The Hub at Tucson

Core Campus Developers | Antunovich Associates Architecture · Planning

Tucson, Arizona | May 15, 2014

Revisions to Exterior Elevations Legend

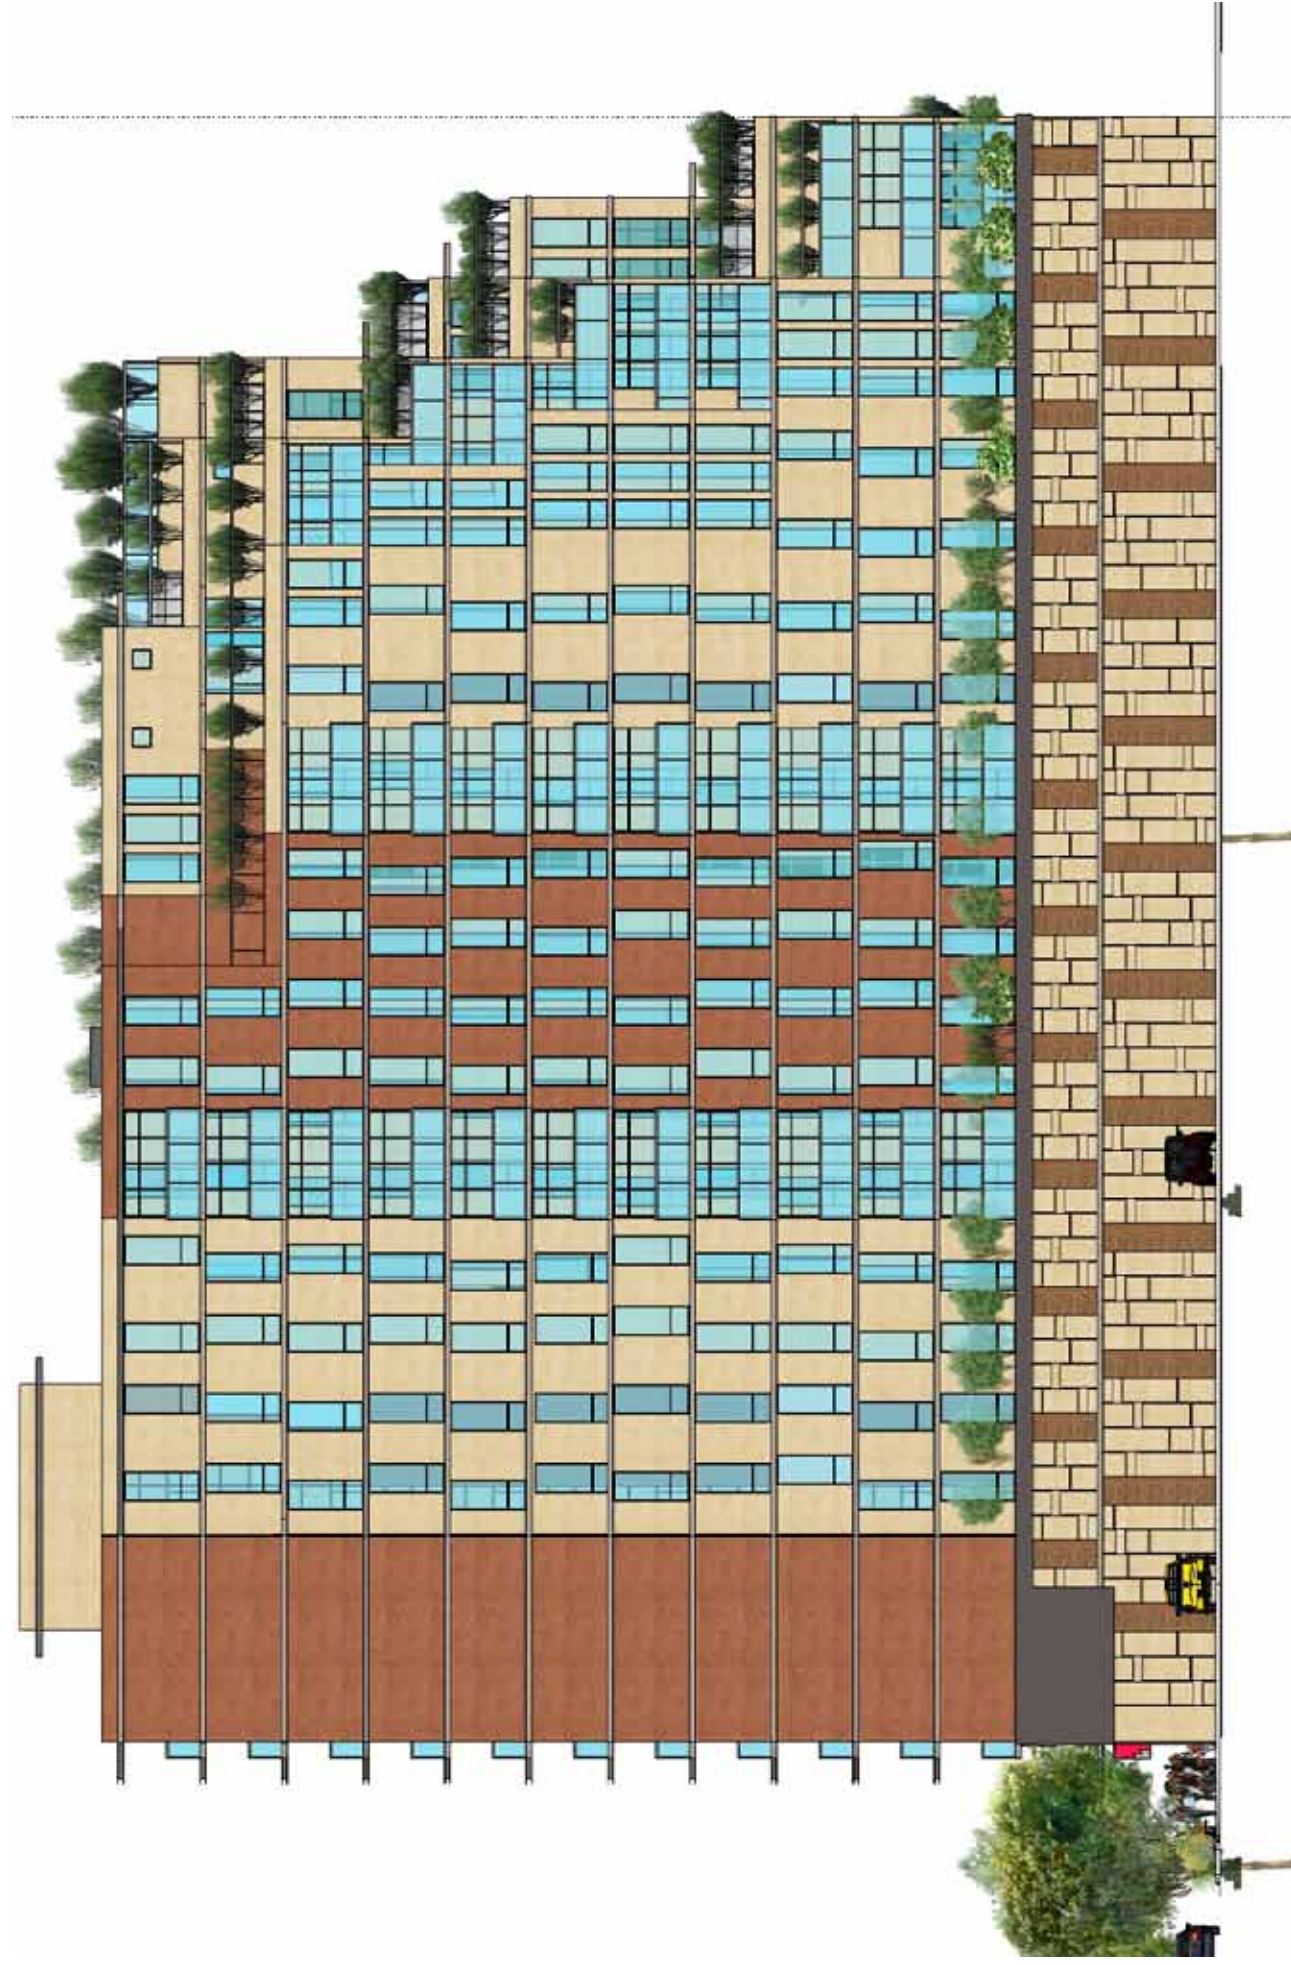
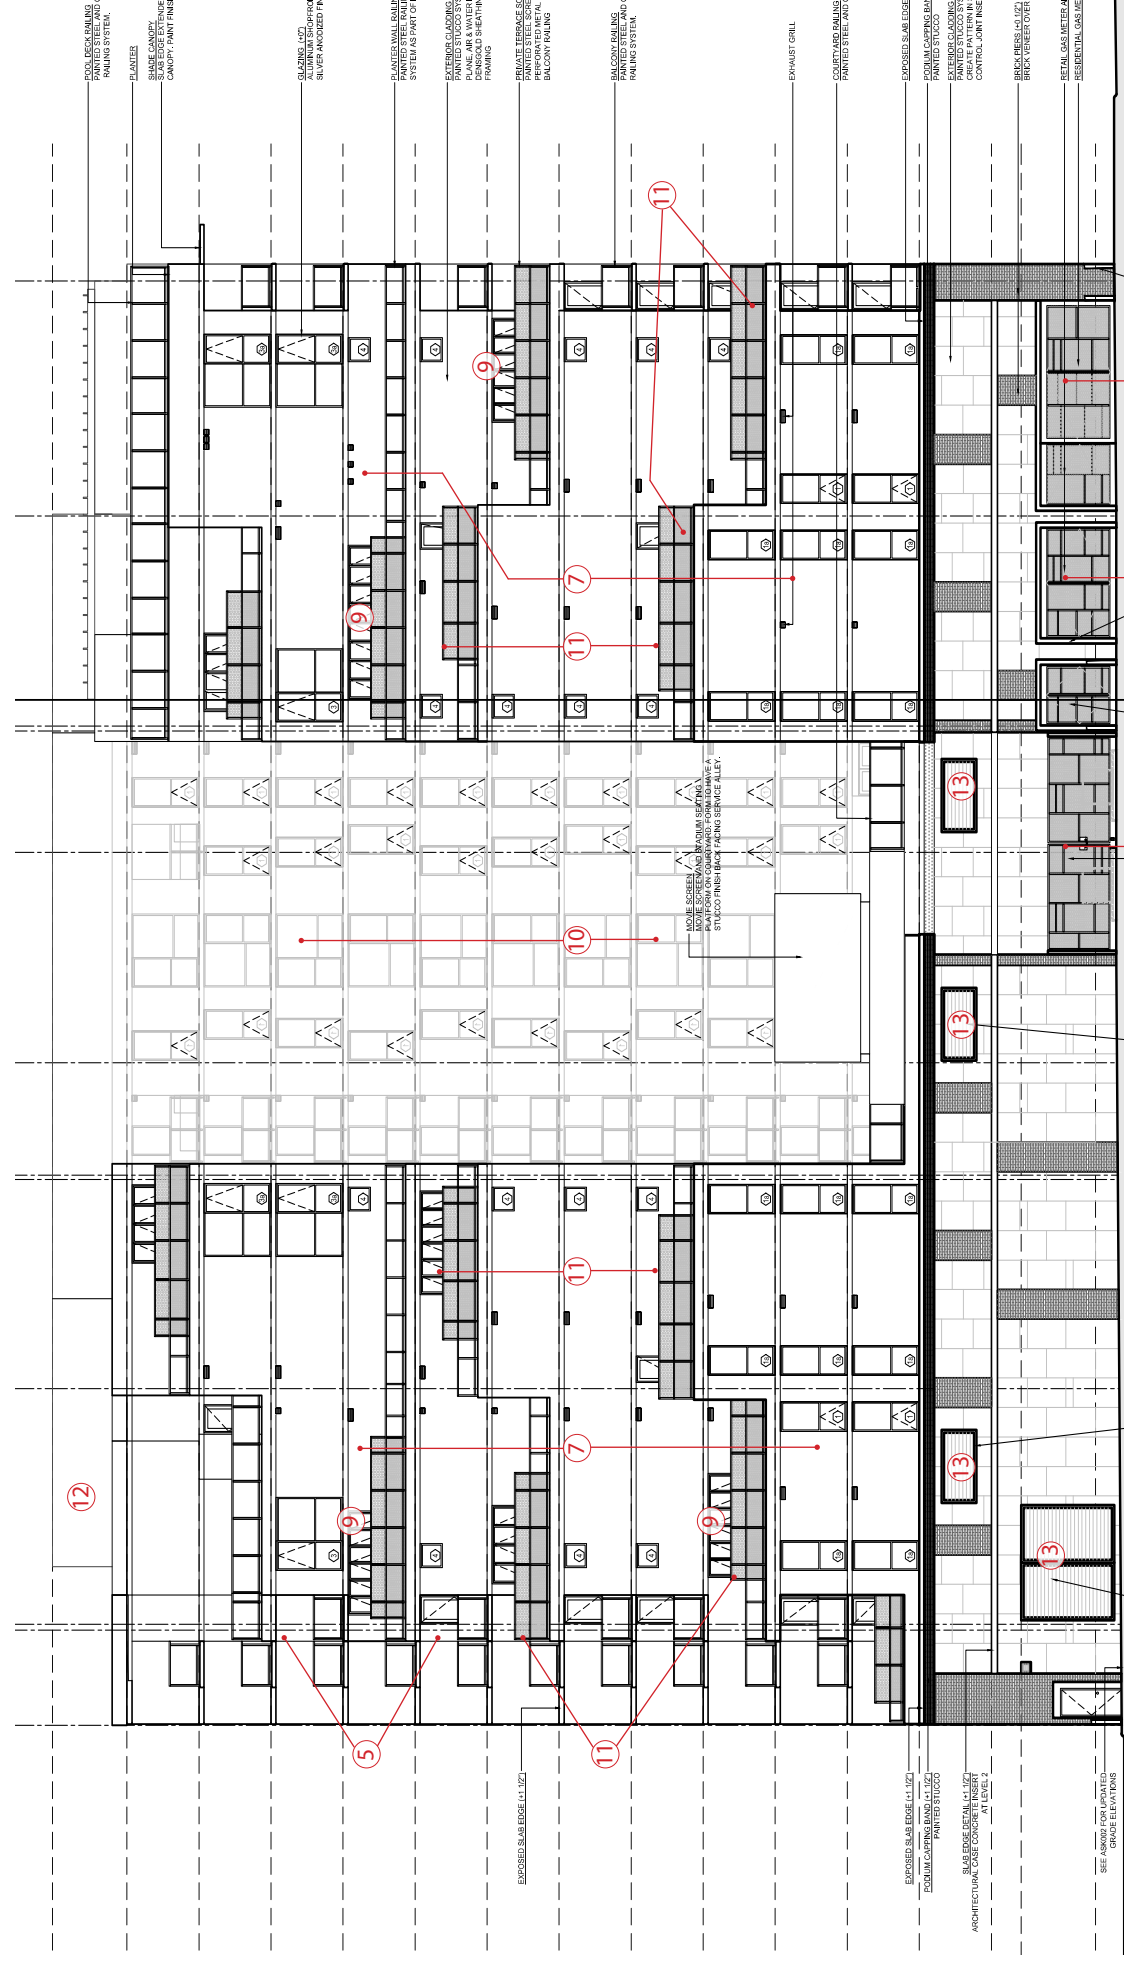
- Denotes revisions on Given facade.
- 1. Grillage at face of building with mechanical equipment behind.
- 2. One large garage opening instead of two smaller openings.

- 3. First floor residential entry framed in stone instead of brick.
- 4. 2 panel full height glass sliding doors in lieu of 3 panel system
- 5. Addition of structural columns at west end of building

- 6. Finished concrete edge detail in lieu of steel
- 7. Revised pattern, less glazing at west end of building
- 8. Revised glazing pattern at 12th floor

- 9. Addition of larger glazing opening
- 10. Revised glazing / opening pattern
- 11. 72" custom perforated aluminum privacy screens around terraces in lieu of code required railing at roof edges

- 12. Addition of stair exit enclosure
- 13. Addition of mechanical grills which match surrounding background.
- 14. Exposed architectural concrete finish in Lieu of painted finish.

FAR WEST ELEVATION
GLAZING AREA

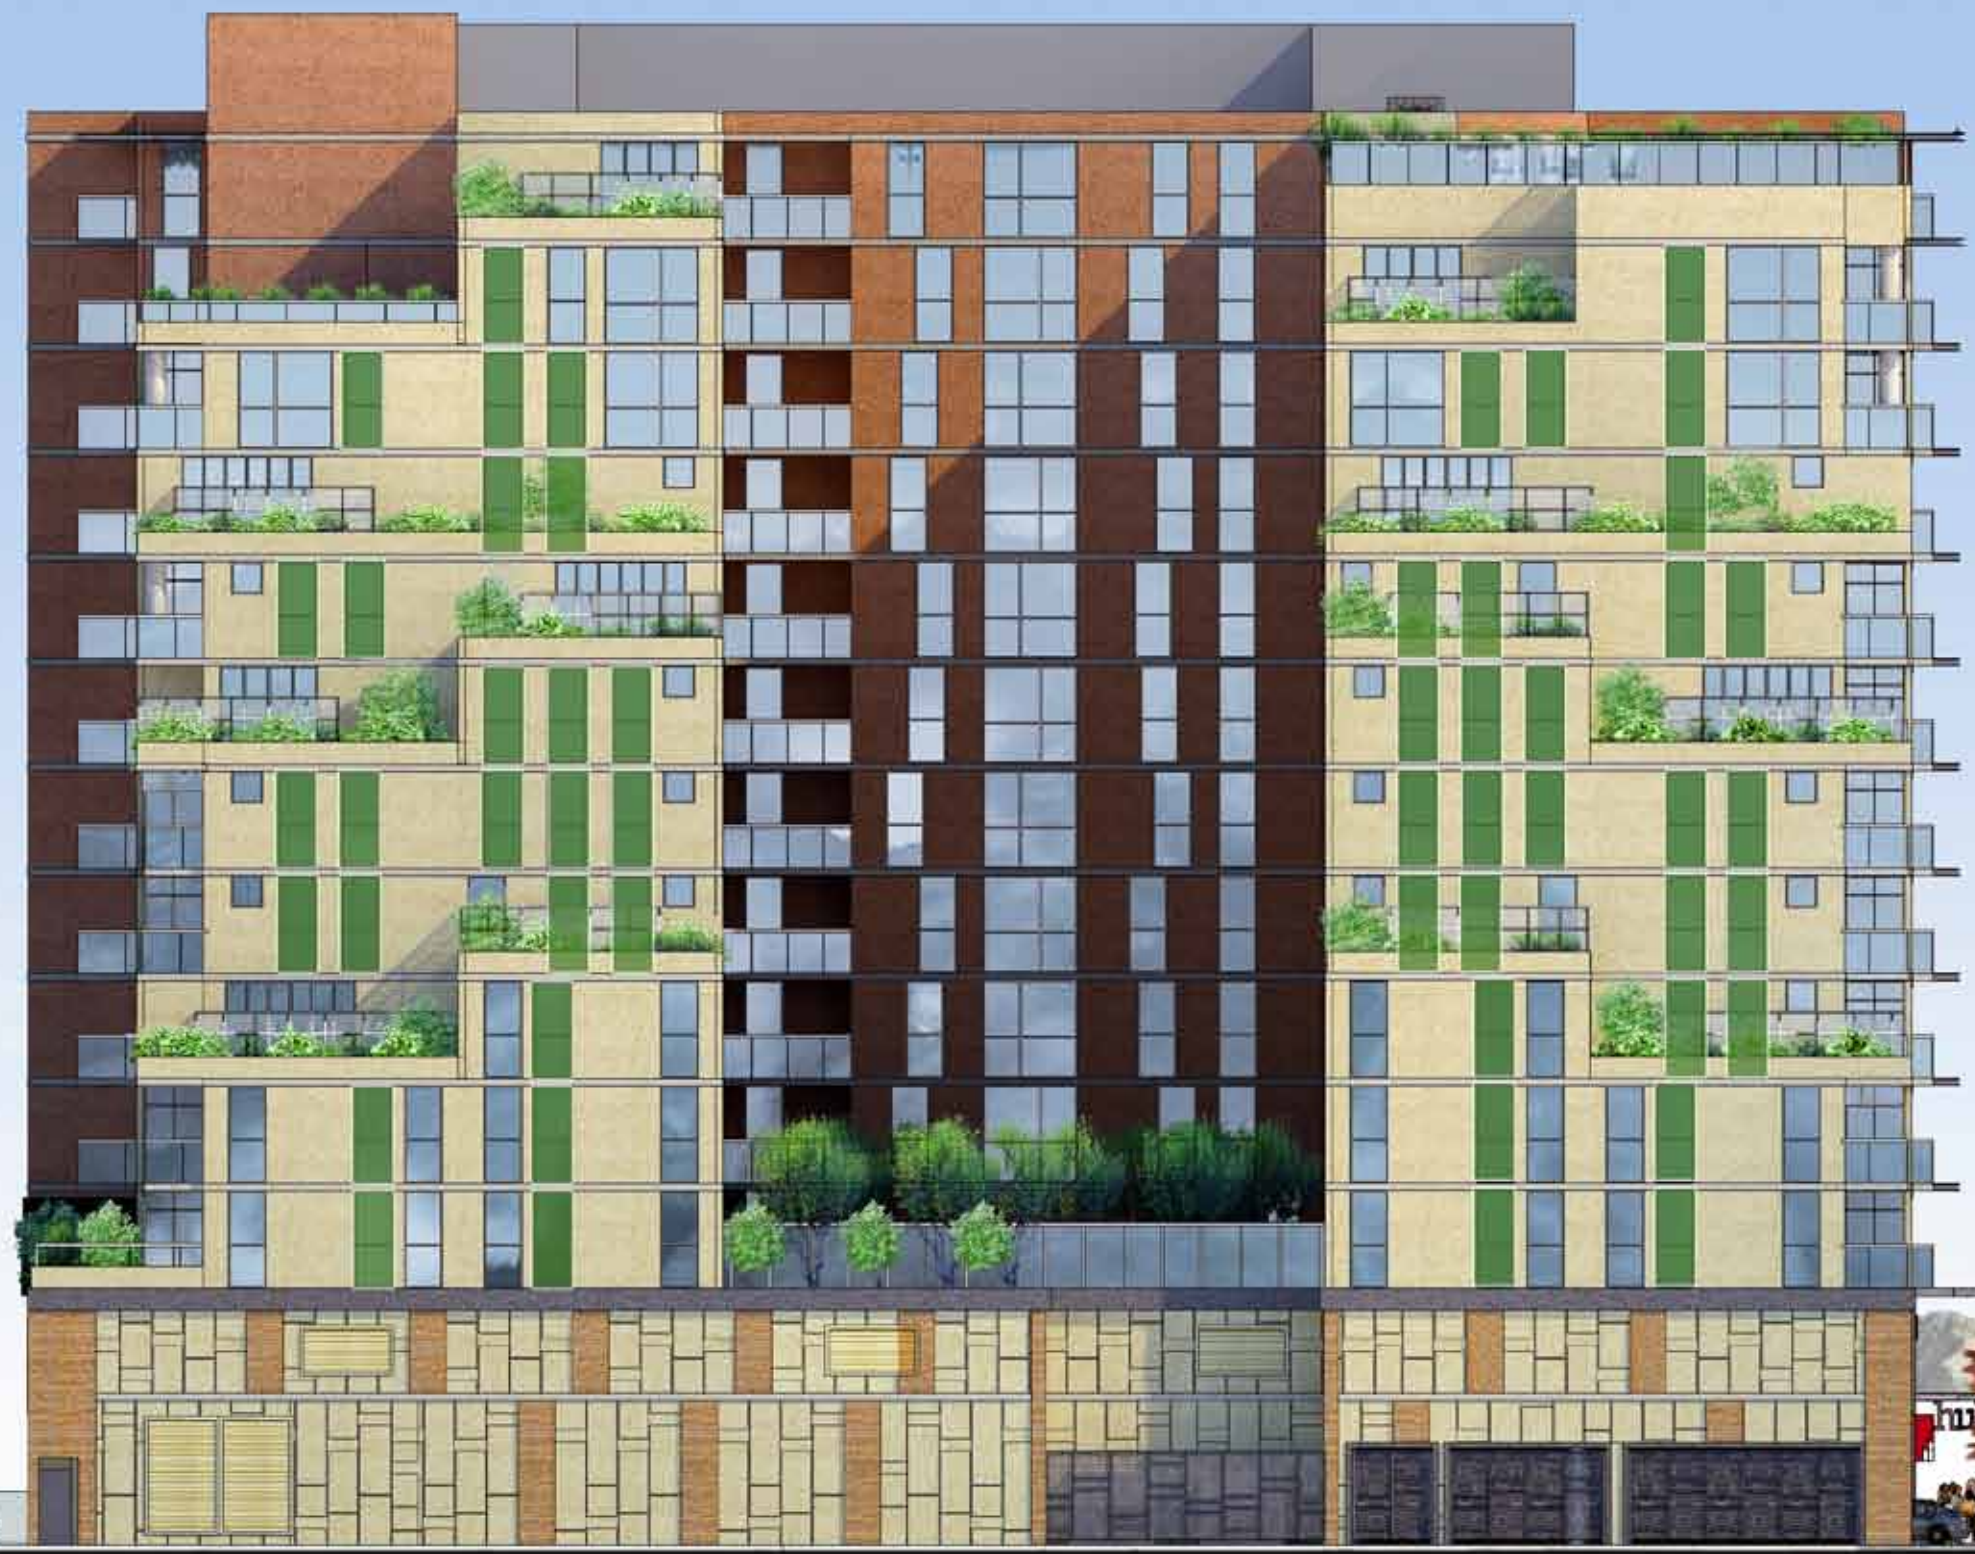
AS BUILT GLAZING AREA - 2,095 sqf
ADDED GLAZING - 1,670 sqf

TOTAL - 3,765 sqf

53 NEW GLAZED PANELS - 1,670 sqf
